Midnite E-Panel/Apollo T80 Shunt Board Issues
Compiled by: John Raynes, RE Solar, Torrey, UT
Date: June 14, 2007

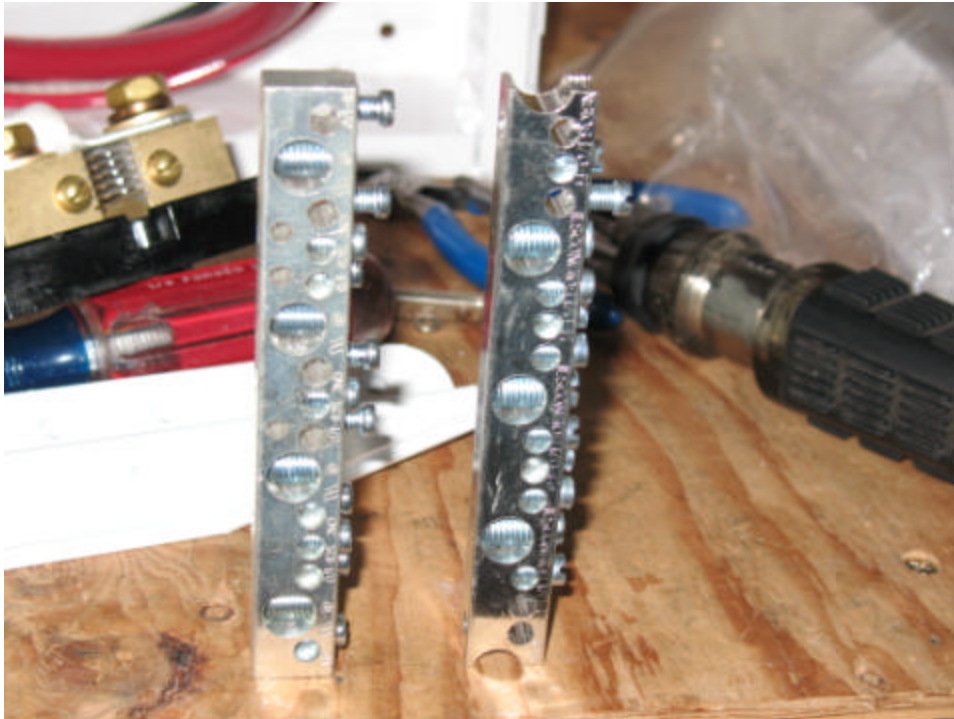
The E-Panel's shunt and neutral bar assembly as configured doesn't allow for the required clearance of the Apollo shunt board.

The neutral bar needs to be shifted up (as seen in the above picture) in order to leave room for the shunt board to overhang when it is attached to the Kelvin terminals (on the underside of the shunt). But doing that would cause the neutral bar to extend up into the ground bar assembly above it, so instead, I flipped the shunt 180 degrees.

I also shifted the shunt to the right a couple of holes so that the neutral bar didn't get too close to the main DC breaker stabs. I could have mounted the neutral bar on the opposite end of the shunt but that would have meant drilling and tapping a couple extra holes and I'm basically a lazy guy.

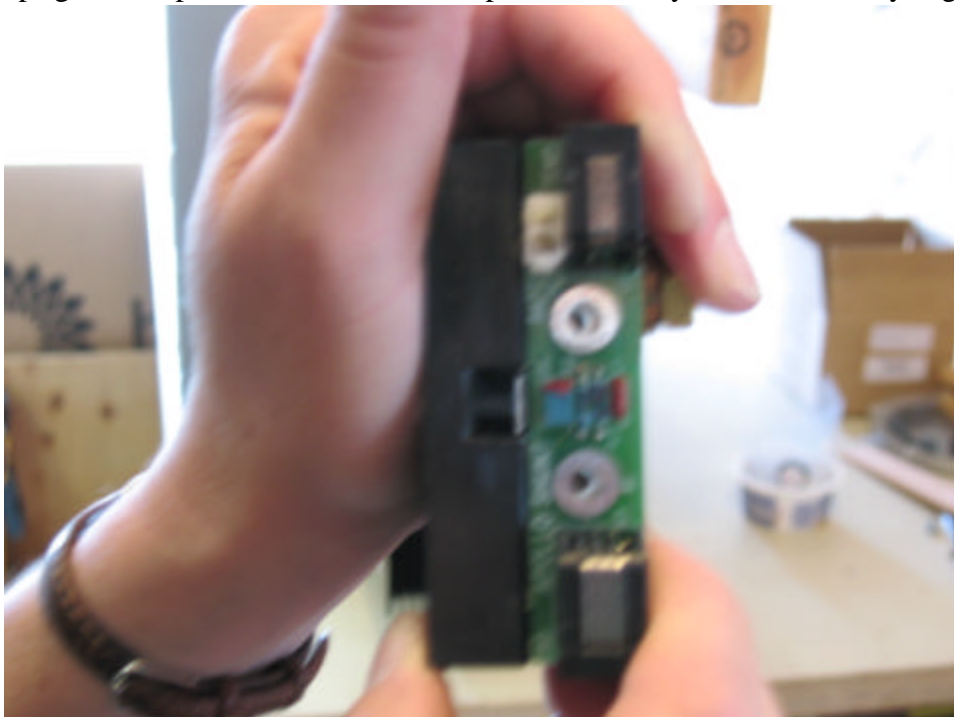
Midnite cuts their bus bars at different places than Outback does, so in Midnite's case the holes at the end of the busbar weren't the same spacing. Fortunately I had an extra Outback busbar, where the holes lined up, so I swapped it out. Remember what I just said about being a lazy guy?

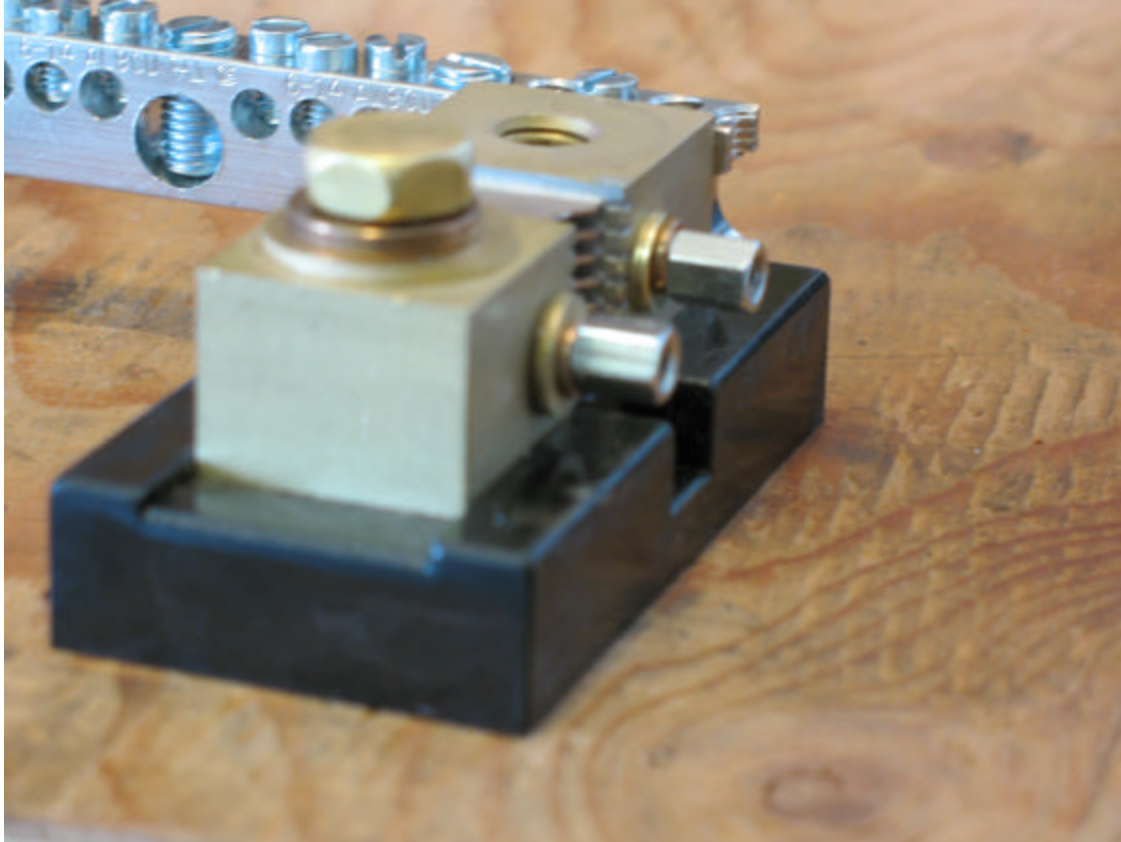
There's an item of note regarding the Apollo shunt board as well. When I went to mount the shunt board to the shunt, the holes didn't line up because the long edge of the shunt board butted up against the phenolic shunt base. The picture isn't very clear but I think you get the idea.

I don't think that this is a Midnite problem per se. I think it is an Apollo problem wherein they didn't leave enough clearance for variation amongst the different shunts that are procured by the power panel guys. I'm guessing that the specs on the locations of the Kelvin terminal drill holes aren't very tight, cause all the slop is accounted for in the final shunt calibration.

Anyway, I built up the standoff height with some extra brass washers I had lying around, and that took care of things, but I think Apollo might want to consider specifying a 7/16" standoff rather than a 5/16", 'cause us wrenches will end up doing some crazy things to deal with this.

I was concerned about using non-brass washers, since there are already so many dissimilar metals in the millivolt signal path (is using an off-the-shelf mechanical standoff as a low-level signal carrying conductor a good idea to begin with)?
